# Proposal to add Cl186 test pattern checkers

Addresses comment 211 against D3.0

Marco Mascitto, Nokia

# Proposed change to Figure 186-3

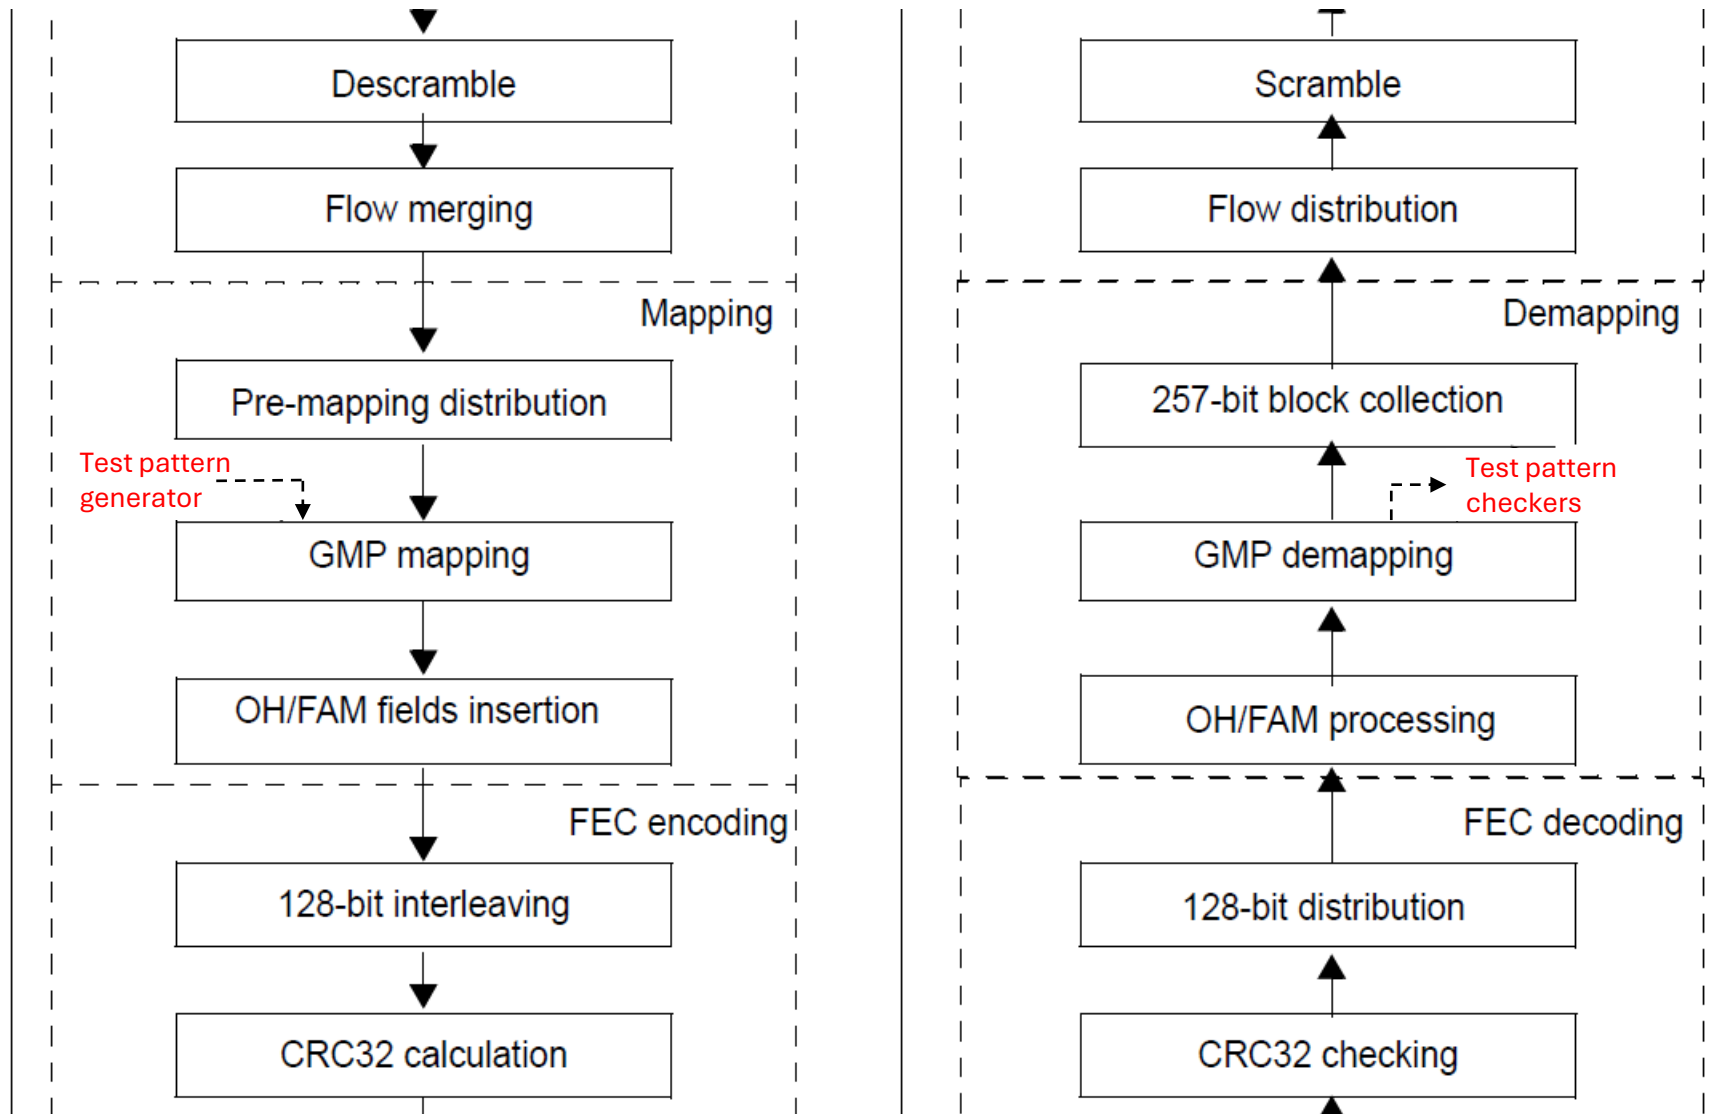
Just as the Transmit function has a Test-pattern generator (subclause 186.2.3.12), there should be a Test-pattern checker subclause to 186.2.4. Figure 186-3 shows both a Test-pattern injection point in the transmit path and a Test-pattern extraction point in the receive path. The Test-pattern checker would be similar in functionality to that in subclause 184.6.2. Support of the subclause could be optional.

- The PRBS31 test pattern generator operates at a nominal rate of 100.385723 Gb/s (+/- 50 ppm).
- Each output bit from the generator is copied into the eight tributary frame payload areas shown in Figure 186-11.
- There needs to be eight instances of PRBS31 test pattern checkers, one for each FEC flow, operating at that same nominal rate of 100.385723 Gb/s (+/- 50 ppm).

When the receive function is in test pattern mode, it operates identically to when it is in normal mode, with the exception that the output of the demapper passes each of the eight FEC flows to an associated pattern checker instance, as described in 186.2.4.11.
